Ronald B. Clary
Vice President
New Nuclear Deployment

October 27, 2010
NND-10-0384

Subject: Virgil C. Summer Nuclear Station (VCSNS) Units 2 and 3
Combined License Application (COLA) - Docket Numbers 52-027
and 52-028 - Voluntary Submittal for the Environmental Report to
Update Figure 3.1-3 and Tables 1.2-1 through 1.2-4

Figure 3.1-3. Site Plan

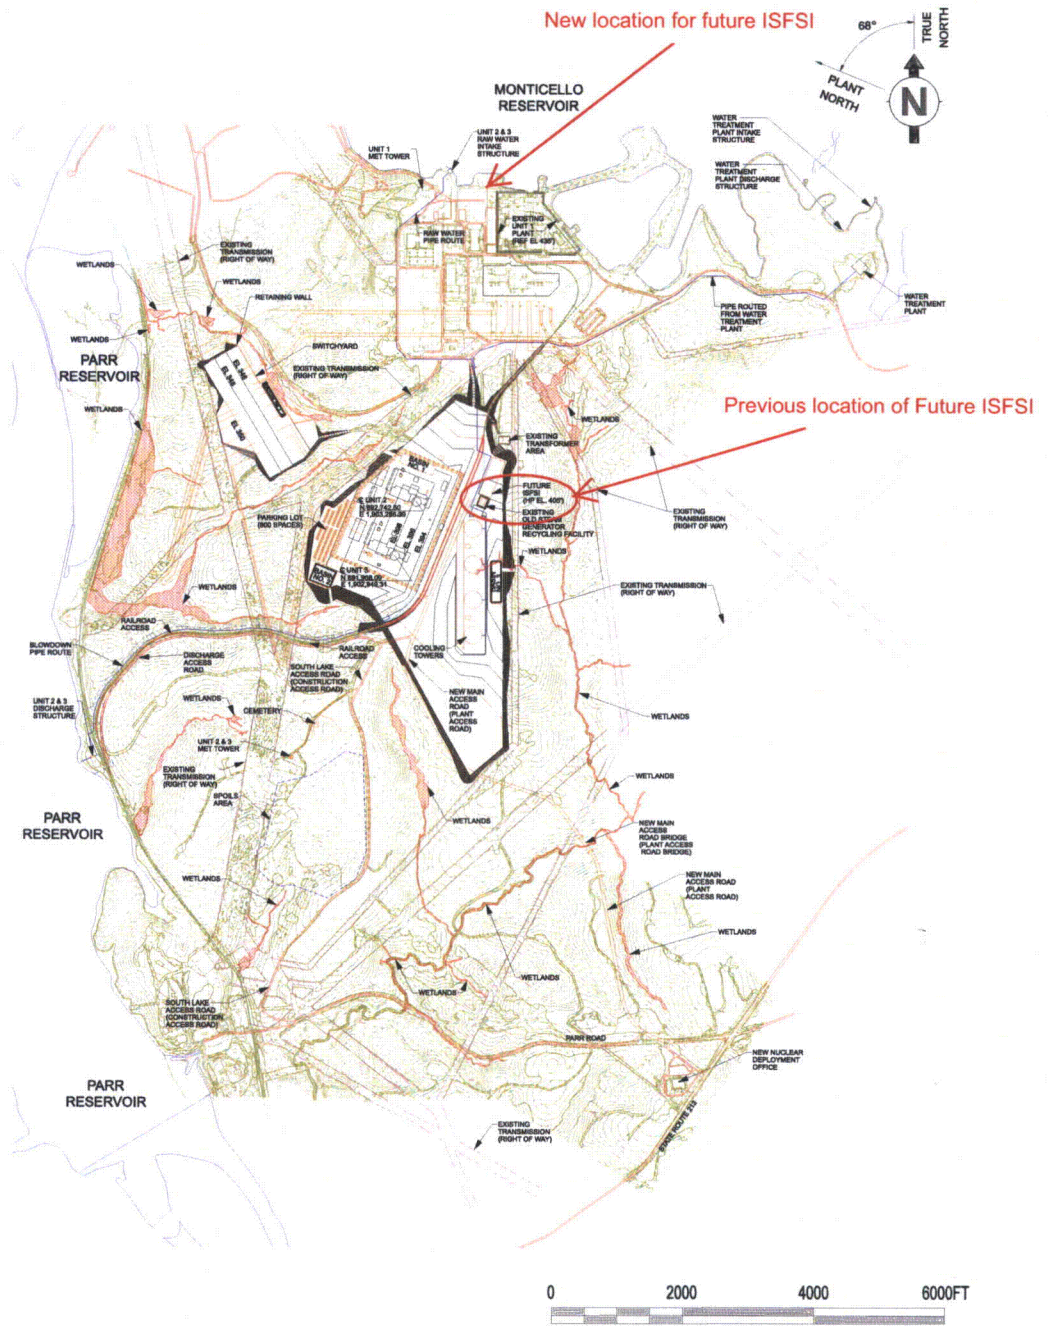
The enclosure to this letter provides an update to ER Figure 3.1-3, Site Plan, to reflect a change to the location of the proposed Independent Spent Fuel Storage Installation from the VCSNS Units 2 and 3 site to the Unit 1 site near Monticello Reservoir. In addition Tables 1.2-1 through 1.2-4, associated with authorizations required for Units 2 and 3, have been updated to reflect the current status of license and permit approvals.
